**SUSQUEHANNA STEAM ELECTRIC STATION
REQUEST FOR ADDITIONAL INFORMATION
REGARDING PROPOSED AMENDMENT NO. 238
TO LICENSE NPF-14: MCPR SAFETY LIMITS
PLA- 5406**

**REQUEST FOR ADDITIONAL INFORMATION REGARDING
PROPOSED AMENDMENT NO. 238 TO LICENSE NPF-14:
MCPR SAFETY LIMITS**

**Response to NRC Request
for Additional Information**

Figure 1
MCPR Safety Limit Methodology

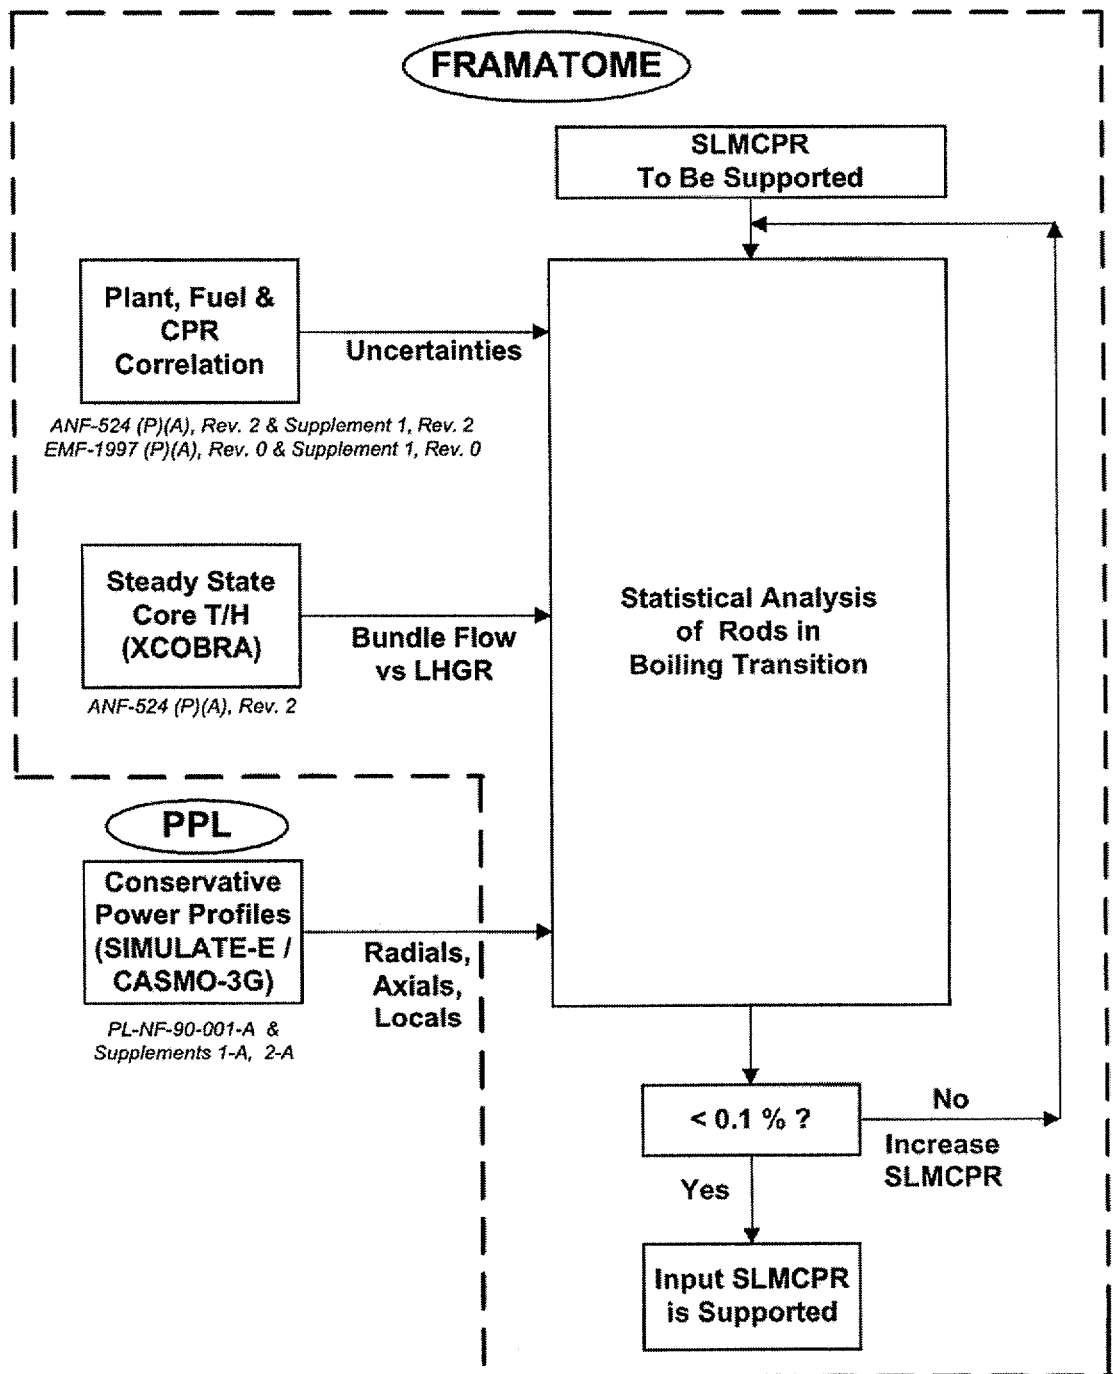
NRC requested a flow chart be provided to: (1) show which TS 5.6.5.b analysis methods are used to calculate the MCPR Safety Limit, (2) identify the calculation flow and (3) indicate which analyses are performed by PPL and which are performed by Framatome - ANP.

Susquehanna Unit 1 Technical Specification Section 5.6.5.b lists a number of approved methodologies that are applied to analyze the behavior of SSES during Cycle 13. Several of these methodologies are applicable to the calculation of the MCPR Safety Limit. Figure 1 provides a flowchart which illustrates the NRC approved methods listed in Technical Specification Section 5.6.5.b, which apply to the separate portions of the Safety Limit analysis and the organization that performs the analysis (PPL Susquehanna, LLC or Framatome - ANP).
